King Street Pump Station Improvements (Volume I) & ASR Lime System Improvements (Volume II) - RFCSP
Solicitation Number: CO-00670
Job No.: 20-6002 and 22-8603

ADDENDUM 12
January 09, 2024

ENLARGED SITE PLAN - MODIFICATION
SCALE: 1"=10'

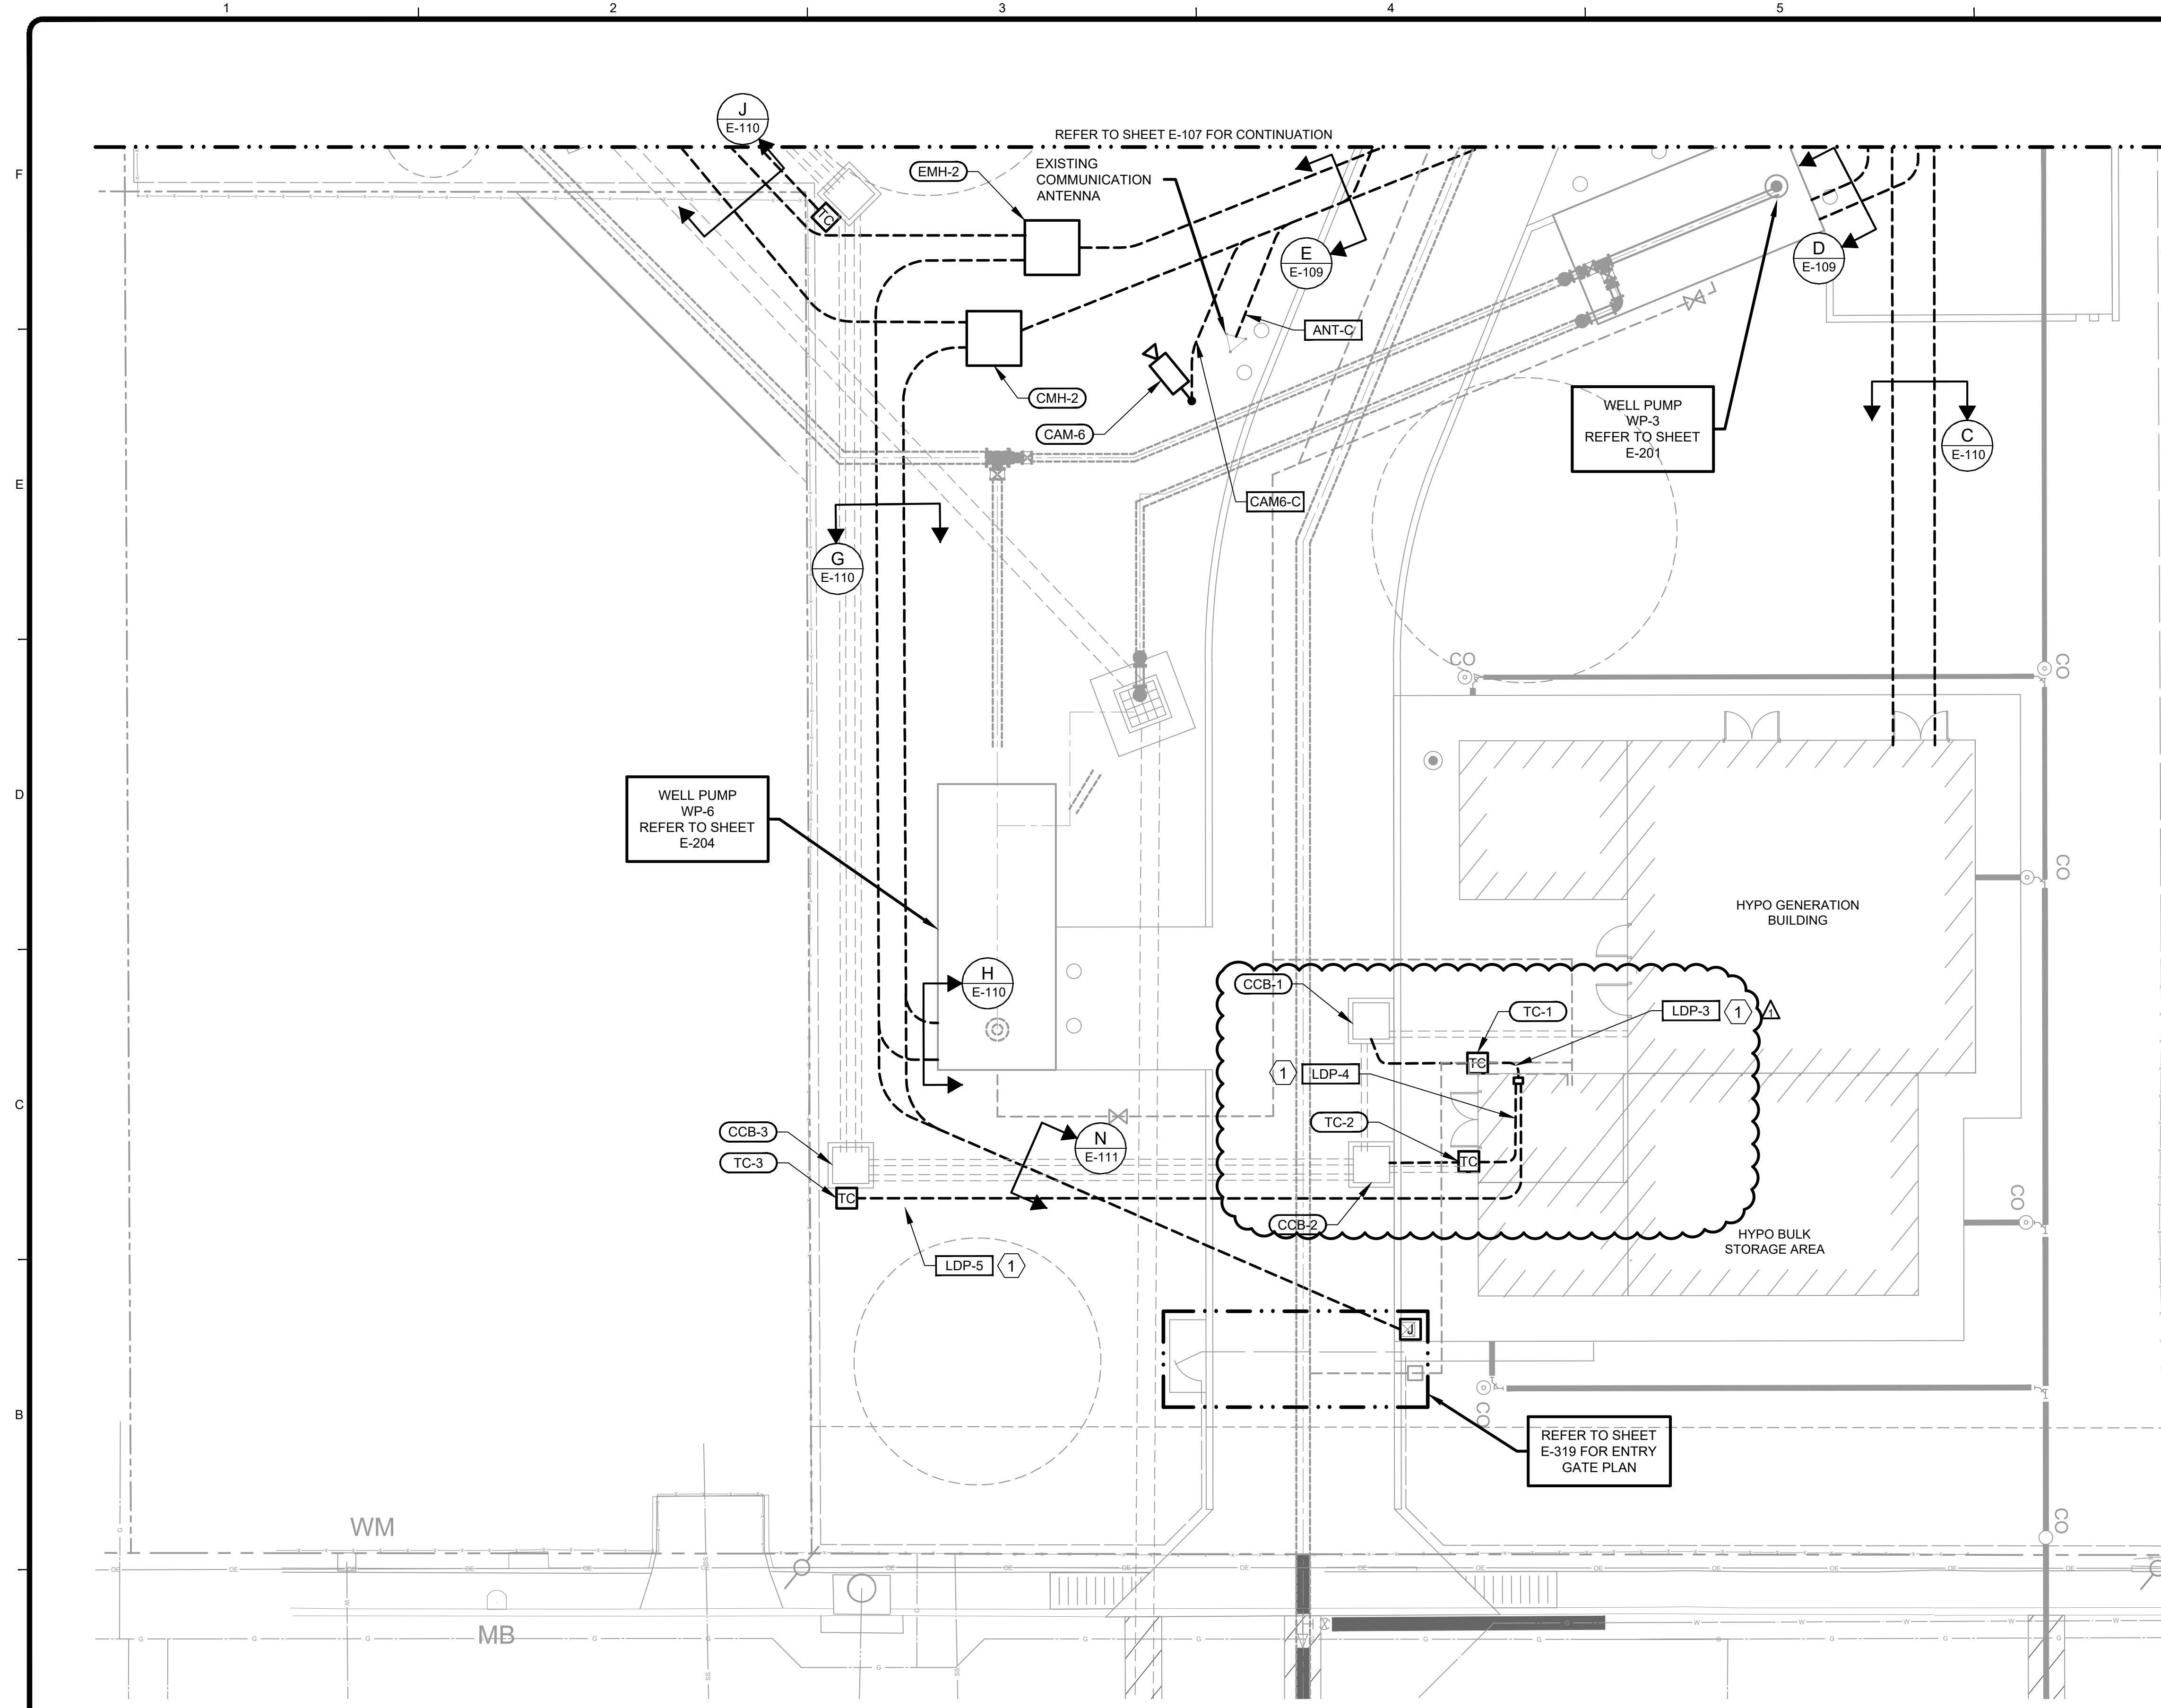
10. **Volume I-King St PS Improvements: The "PIPE MATERIALS SCHEDULE" table in drawing D-001 lists both fluoride and hypo systems as double contained. In the subsequent drawings the Fluoride systems has visible double containment, tags showing so, and tags showing the location of the low point leak detection sensors. In the Hypo system there is no visible double containment nor tags for the exposed/above ground portion, or defined locations for the leak detection. We want to confirm what are the above ground locations where the Hypo system needs double containment.**

Response: Double containment and leak sensors for hypo system shown. Refer to "Changes to Plans" Item No 5, Item No 6, Item No 7, Item No 8, Item No 9, Item No 11, Item No 12, Item No 13 and Item No 14.

- DELETE in its entirety and REPLACE with the attached.
10. DRAWING D-308: ADDITIONAL BUILDING SECTIONS
 - ADD the sheet to the plan set.
11. DRAWING E-108: SITE PLAN MODIFICATION ENLARGED VIEW-II
